## IVAR KARISSON SUBDIVISION

APPLICATION NUMBER 5 DATE November 5, 2009

REQUEST Subdivision

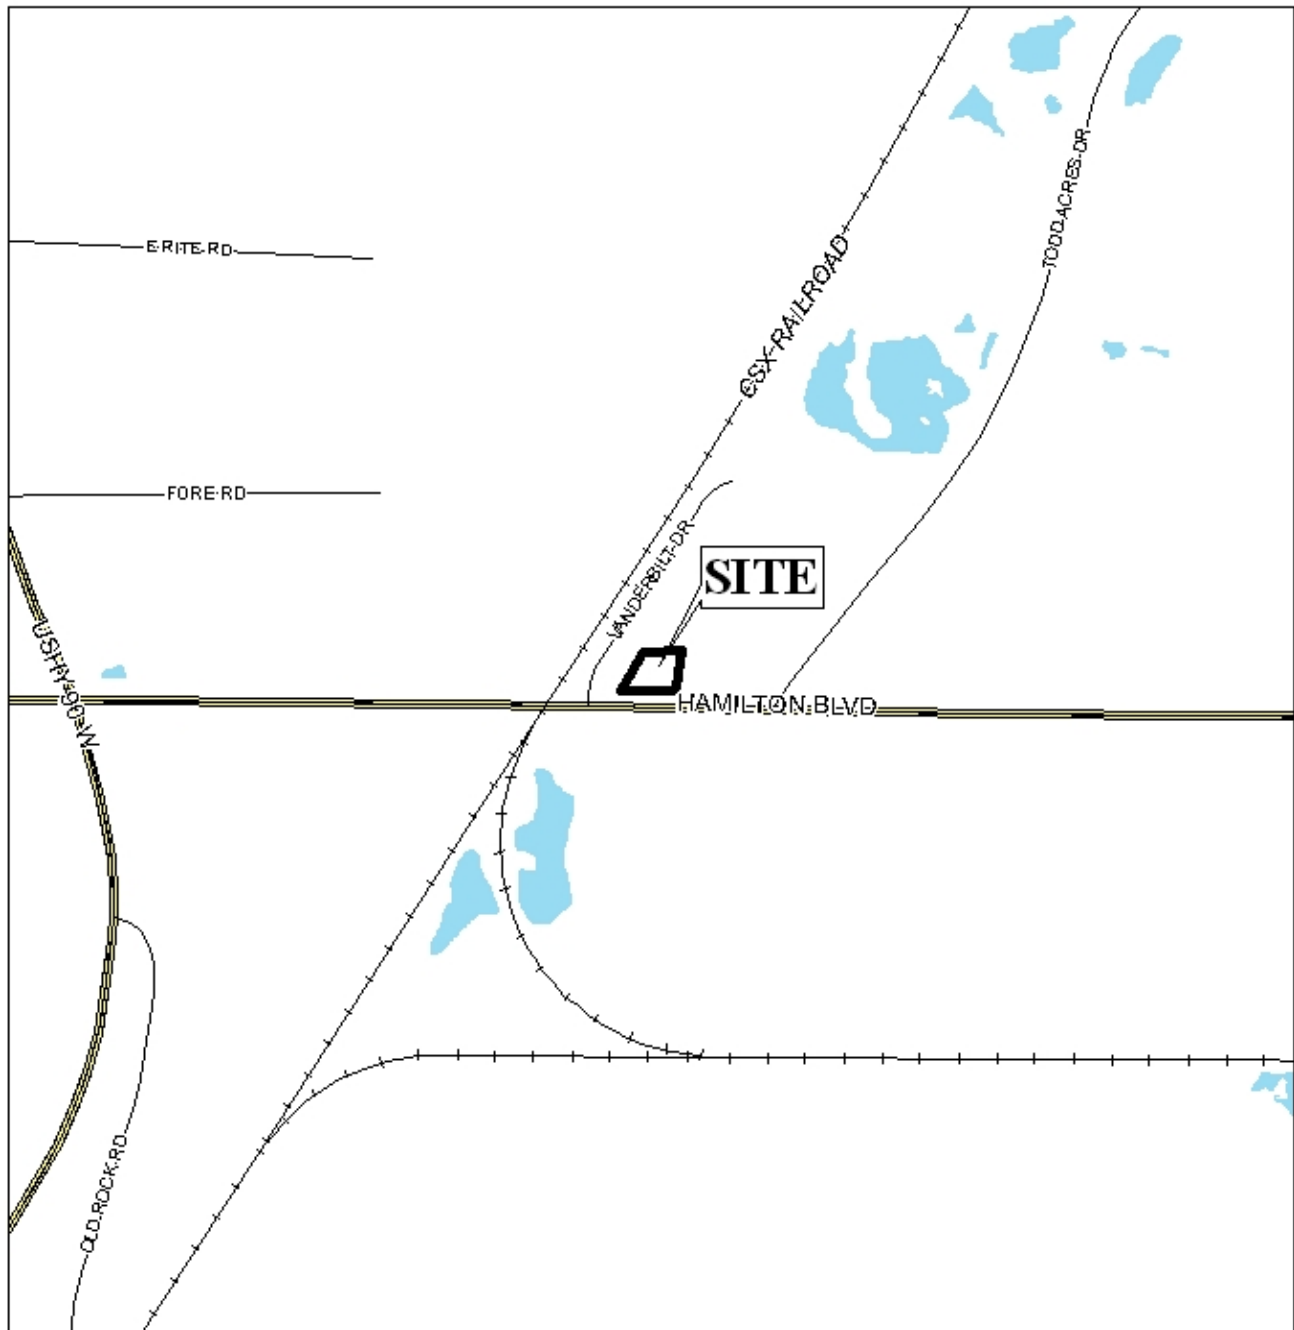
The site fronts Hamilton Boulevard, a proposed major street, with 80' of right-of-way. As a proposed major street, the Major Street Component of the Comprehensive Plan requires a 100' of right-of-way. Therefore, dedication should be required to provide 50' from the centerline.

The subdivision has approximately 144' of frontage along Hamilton Boulevard. As a means of access management, a note should be placed on the final plat stating that the subdivision is limited to the two existing curb cuts to Hamilton Boulevard.

The proposed lot size is indicated on the plat in square feet, and should be retained on the final plat, if approved.

The 25-foot minimum building setback line is depicted on the preliminary plat and should be retained on the final plat, if approved.

The plat does not meet the minimum size requirement for developments with access to public water and individual septic tank. Section V.D.2 of the Subdivision Regulations requires that the minimum dimensions for a lot served by public water and individual septic tank shall be at least 15,000 square feet. The proposed lot is 14,373 square feet and dedication of right-of-way will further reduce the lot size: the provision of public water and sewer will be required for a proposed lot size of less than 15,000 square feet.

- 1) The lot size does not comply with Section V.D.2 of the Subdivision Regulations.
